DRAWING REVISION NOTES:
SHEET 2 OF SDP-99-054 (COLUMBIA GATEWAY) HAS BEEN REVISED TO PRESENT THE PROPOSED ENTRY & EMPLOYEE LOUNGE SPACE DESIGNS. THE PROVIDED LEGEND CLARIFIES THE SYMBOLS UTILIZED ON THE DEVELOPMENT PLAN. THE PLAN ILLUSTRATES THAT 11 TREES WILL BE REMOVED & 25 WILL BE PLANTED. THE EXISTING BOLLARDS WILL BE REMOVED & 16 NEW BOLLARDS WILL BE INSTALLED. A PAVILION, RETAINING WALL & HARDSCAPE WILL BE ADDED TO THE EMPLOYEE LOUNGE WHILE AREAS OF PLANTING WILL BE ADDED IN PLACE OF HARDSCAPE AT THE ENTRY AS WELL AS 3 FLAGPOLES & 12 POST LIGHTS.

SITE DEVELOPMENT PLAN
COLUMBIA GATEWAY
Parcels T-1, T-2, T-4 and T-5
Plat # 13402 thru 13404 & Plat No. 18716

SDP 99-54

Plan - Phase I Limits
 scale: 1"=50'

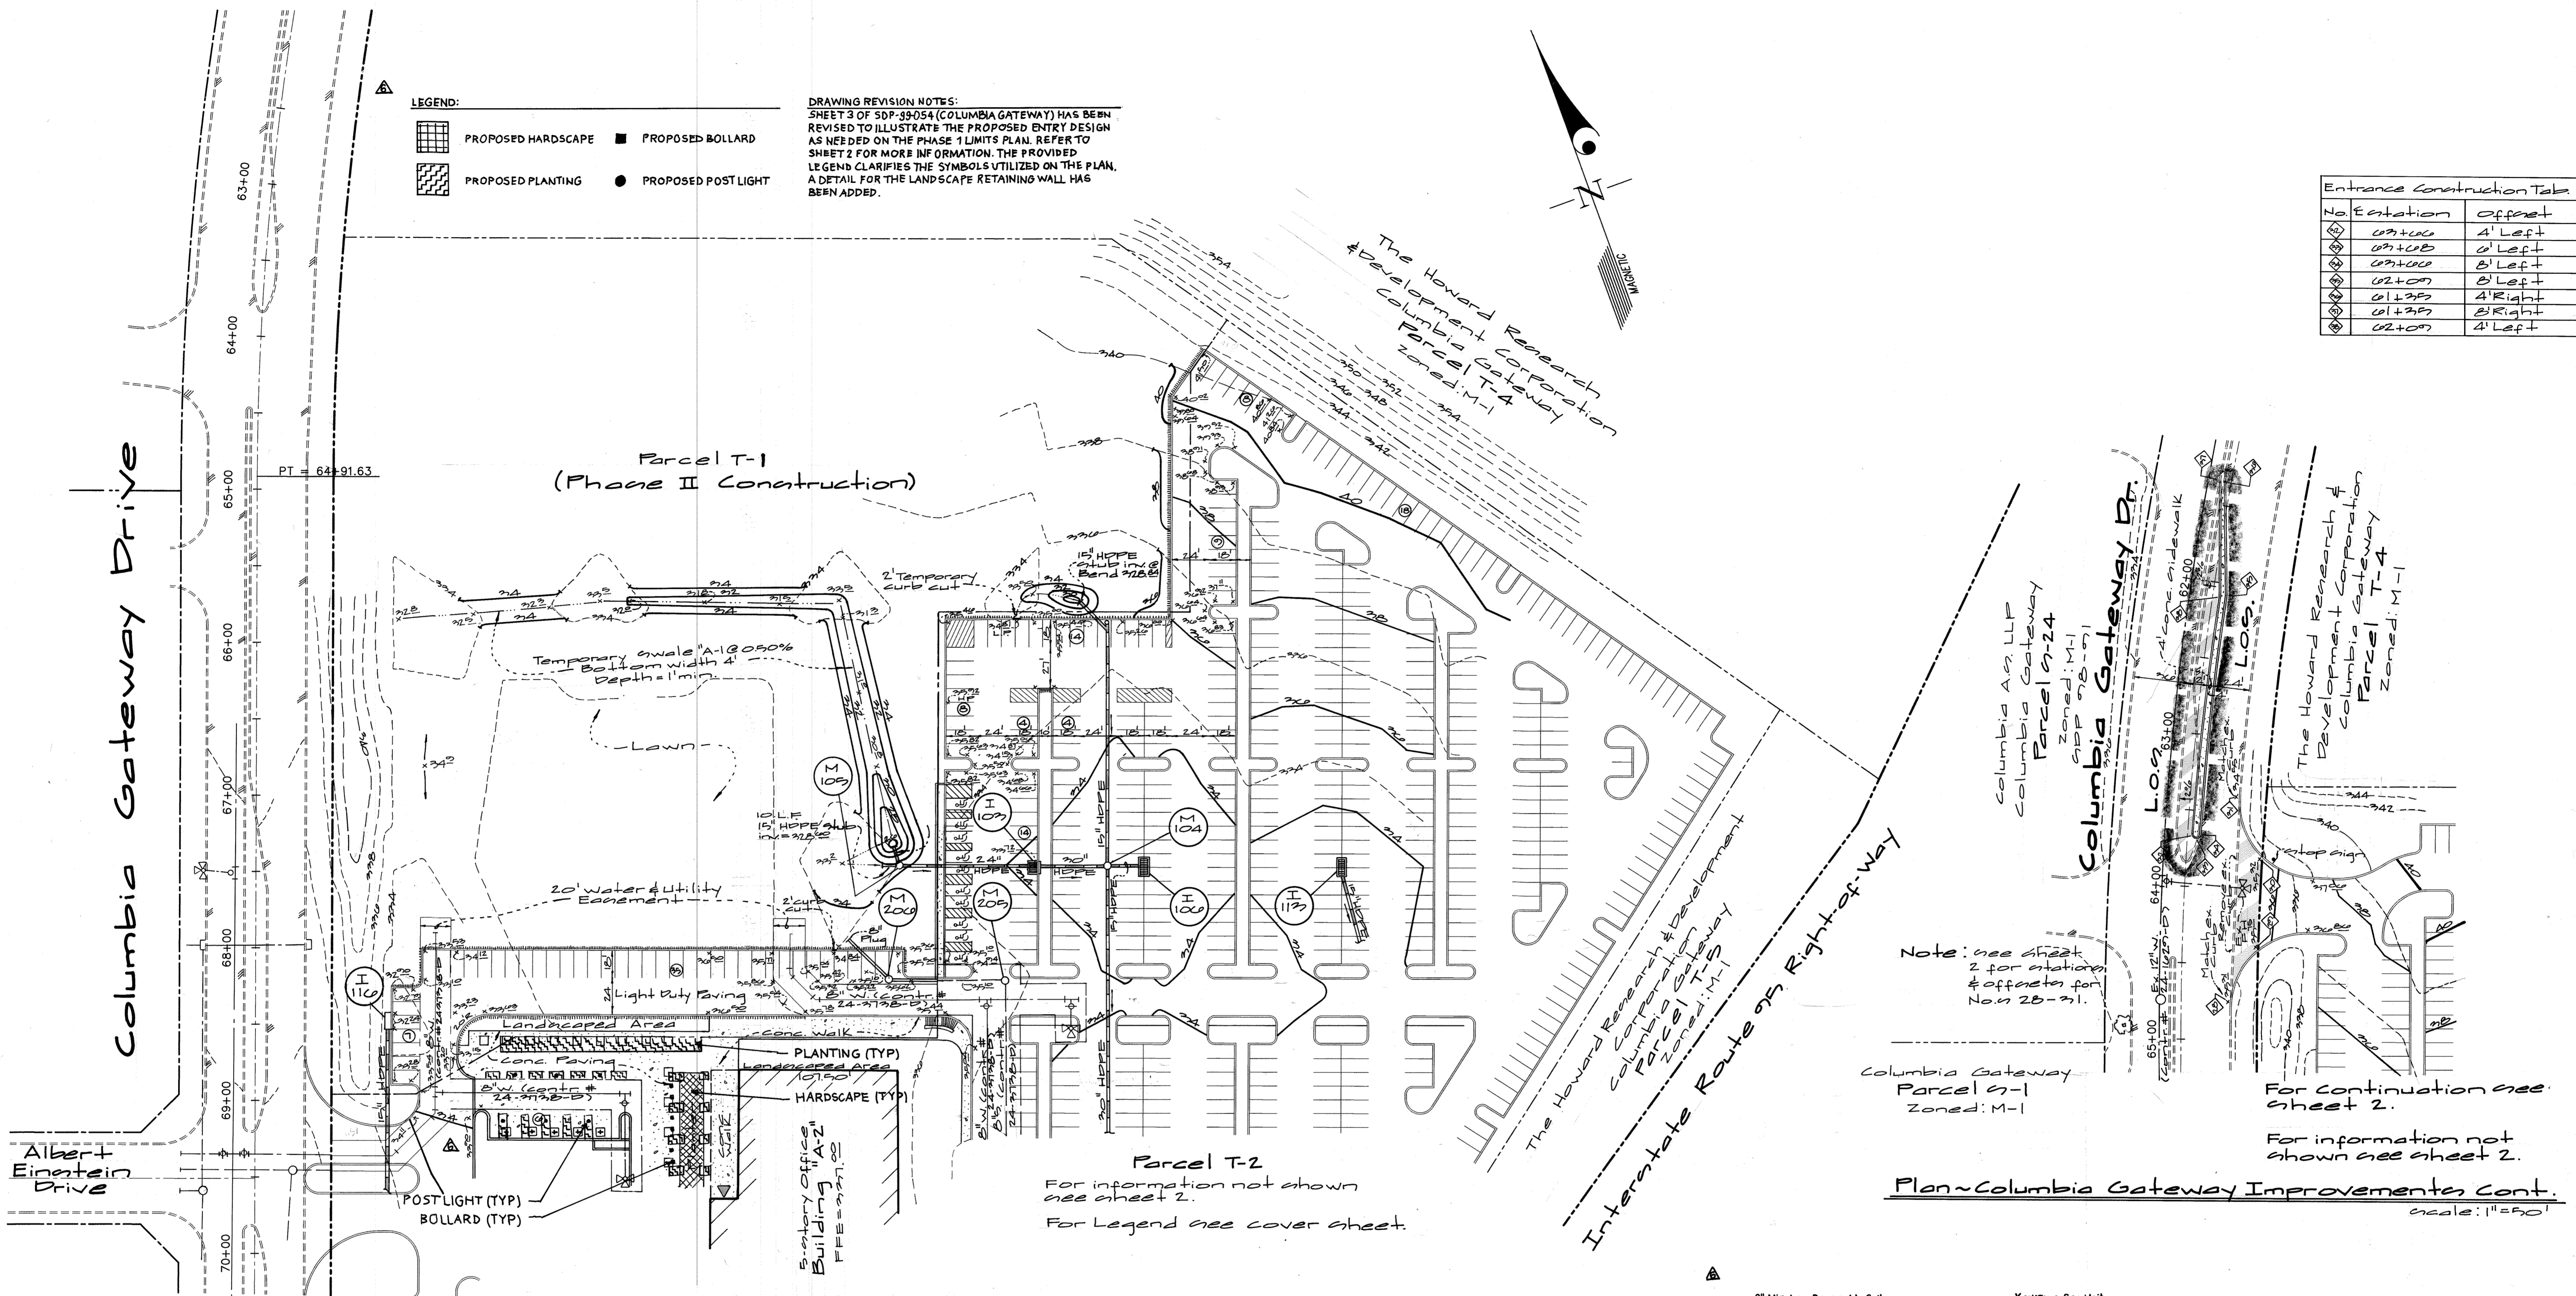
DRAWING REVISION NOTES:
 SHEET 3 OF 5DP-99-054 (COLUMBIA GATEWAY) HAS BEEN REVISED TO ILLUSTRATE THE PROPOSED ENTRY DESIGN AS NEEDED ON THE PHASE I LIMITS PLAN. REFER TO SHEET 2 FOR MORE INFORMATION. THE PROVIDED LEGEND CLARIFIES THE SYMBOLS UTILIZED ON THE PLAN. A DETAIL FOR THE LANDSCAPE RETAINING WALL HAS BEEN ADDED.

Handicap Site Details & Paving Plan
COLUMBIA GATEWAY
Parcels T-1, T-2, T-4 & T-5
Plot No. 13402 Thru 13404
& Plot No. 18716
ELECTION DISTRICT No. 6
HOWARD COUNTY, MARYLAND

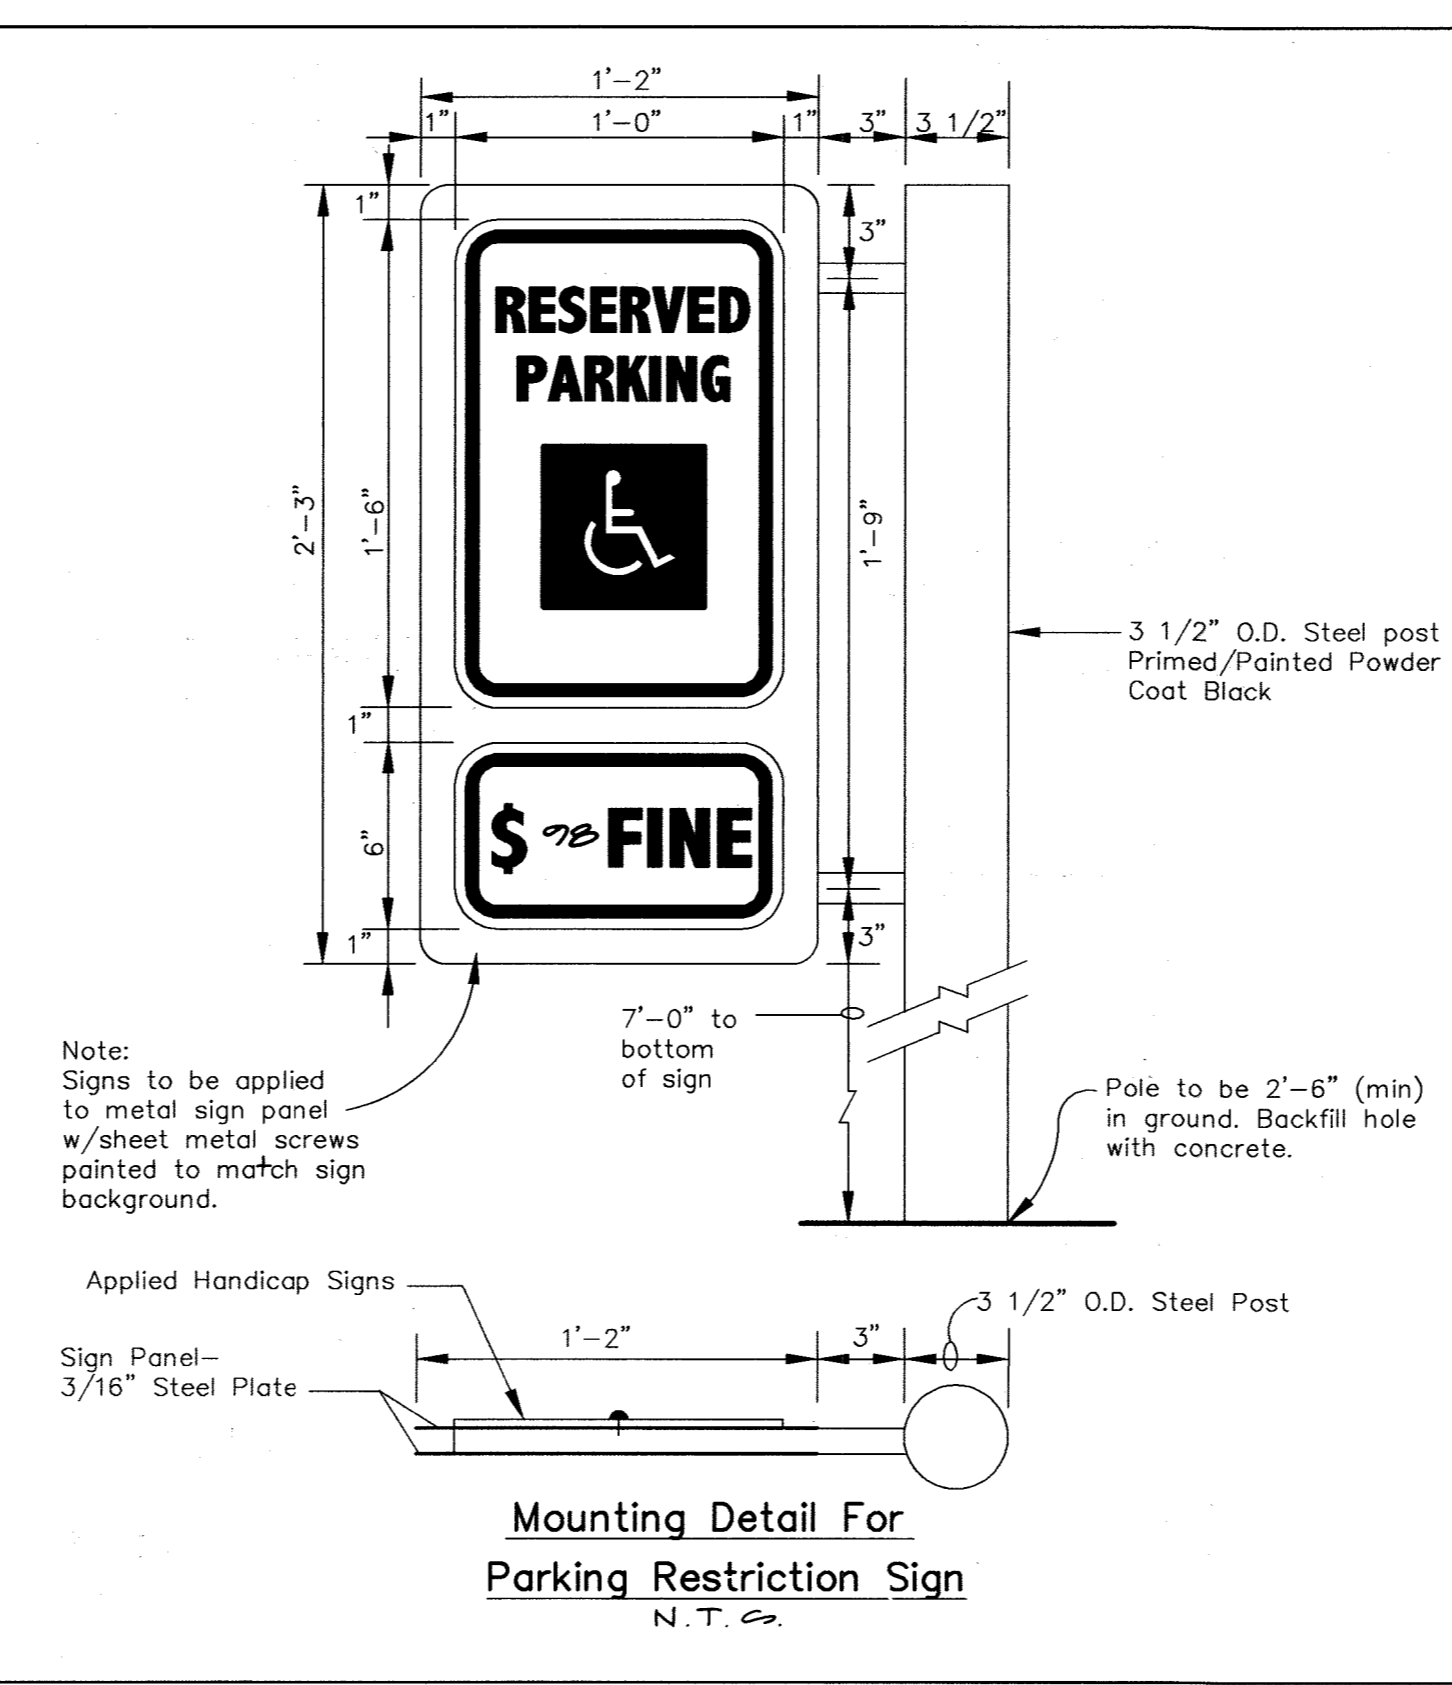
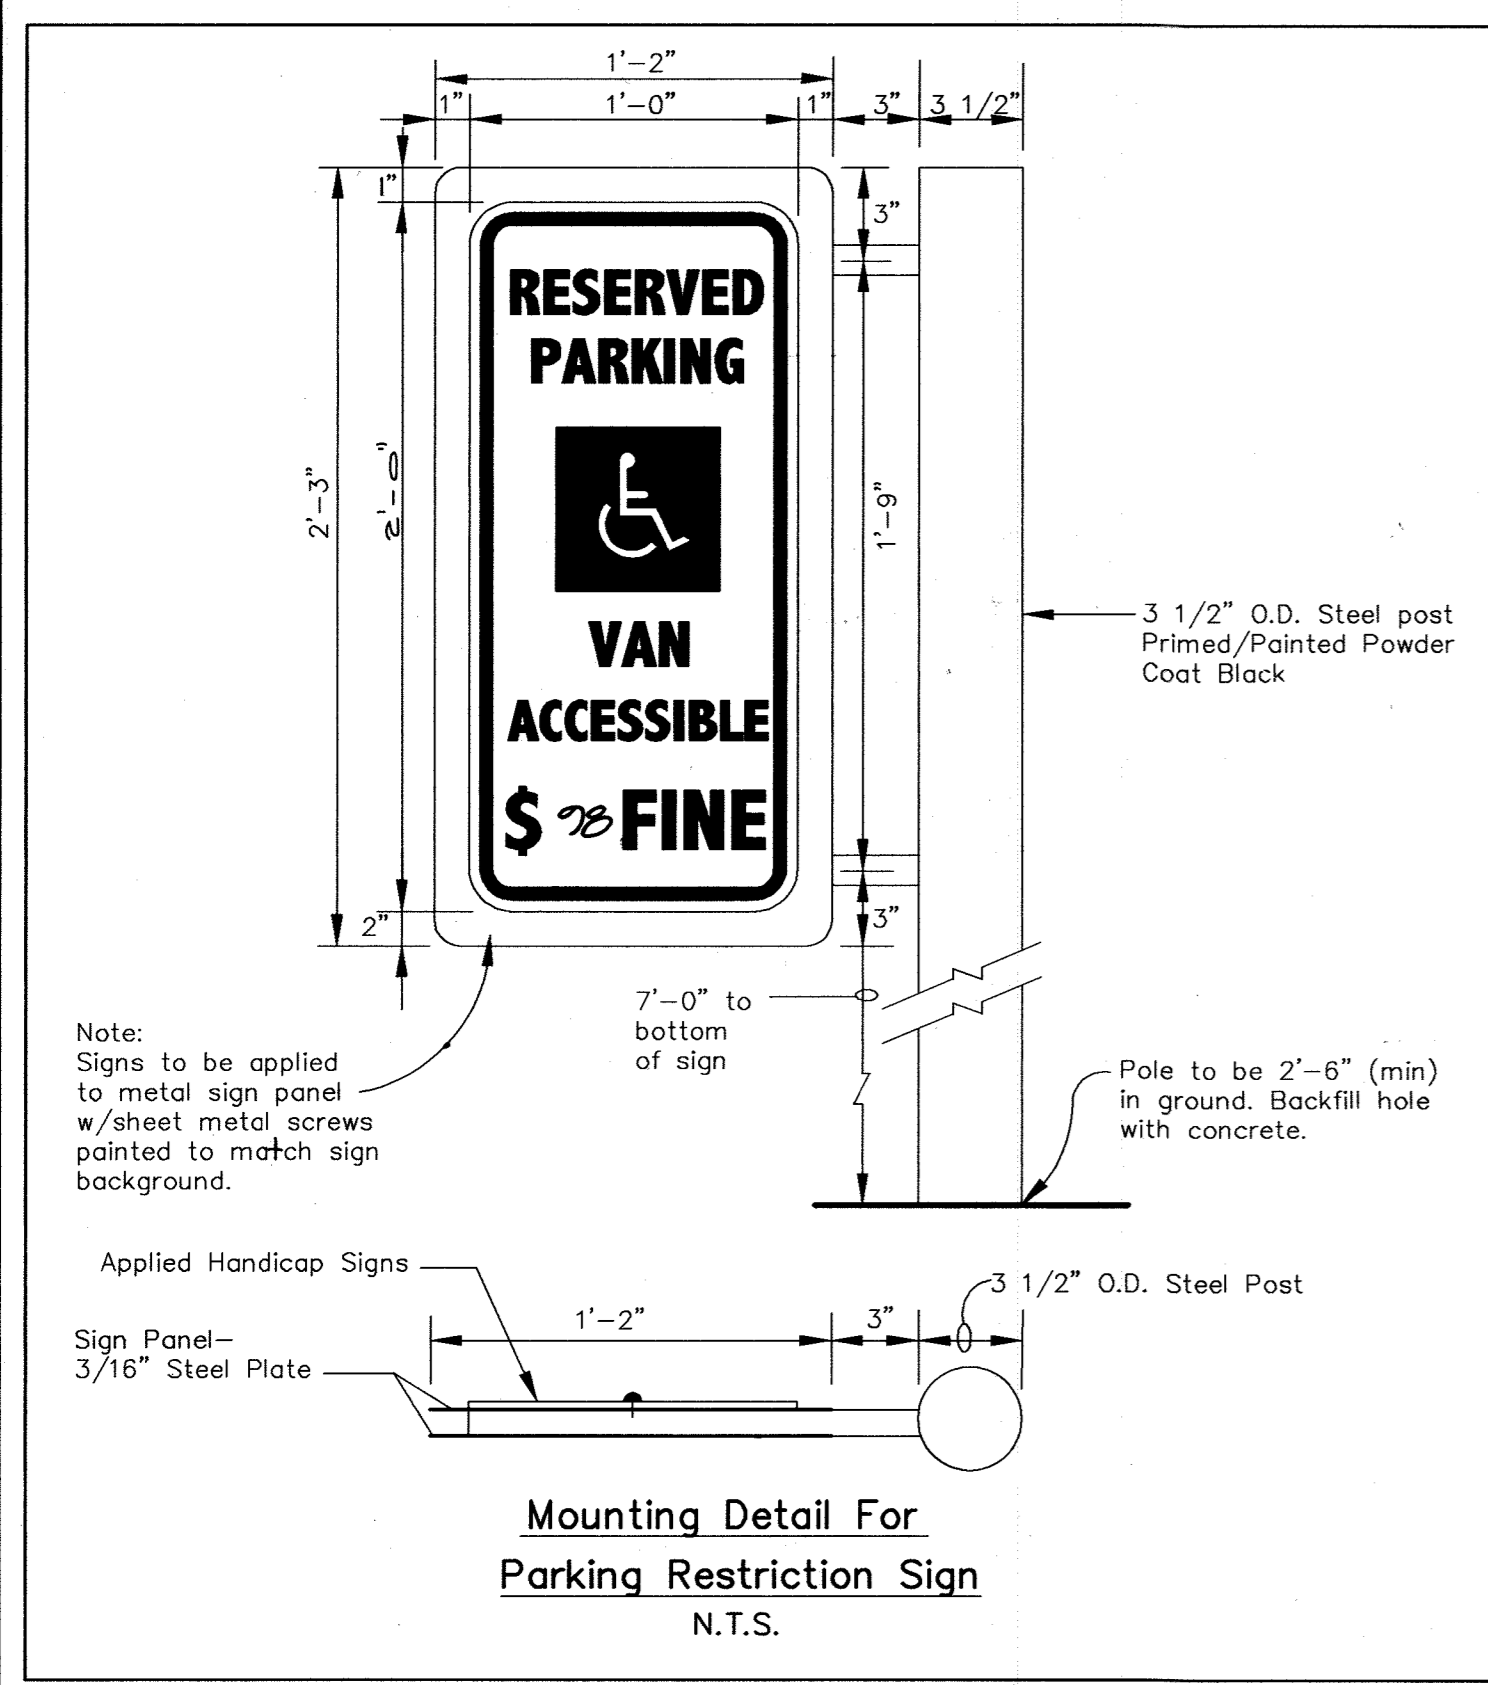
DRAWING REVISION NOTES:
SHEET 6 OF 5DP-99-054 (COLUMBIA GATEWAY)
HAS BEEN REVISED TO INCLUDE A DETAIL
DEPICTING THE DIMENSIONS OF THE
PROPOSED PAVILION.
